Technical Service Information

4L80-E

CASE COOLER LINE FITTINGS

Figure 1

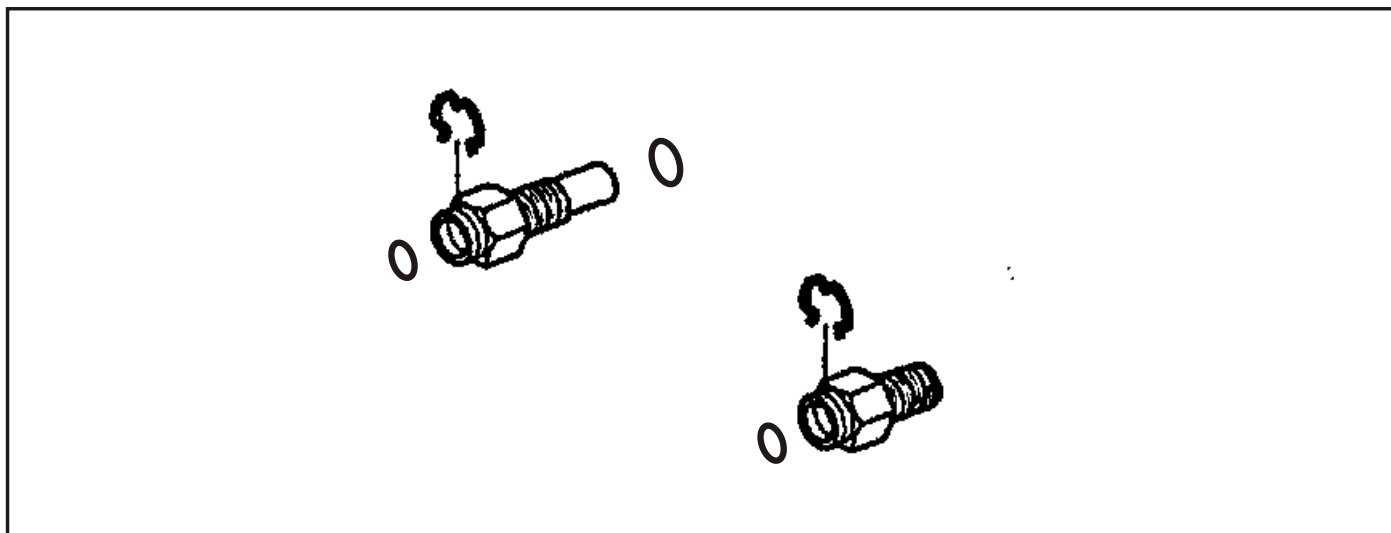
CORRECTION: 1997 and later center lube transmissions had the oil cooler return line relocated to direct oil returning to the transmission from the cooler directly into the center support at the middle area of the case instead of returning to the pump as in the 1996 and earlier units. This change also made a redesign of the case fittings necessary. The profile of the rear fitting was changed to make it longer so that the inner end will fit into a seal in the center support. At the same time, the front fitting as well as the rear fitting, was modified for quick connect / disconnect in place of the earlier flared line / threaded type. (See figure 1)

Retaining clip only - 24205103
Front fitting with clip - 24205102
Rear fitting with clip - 24207013
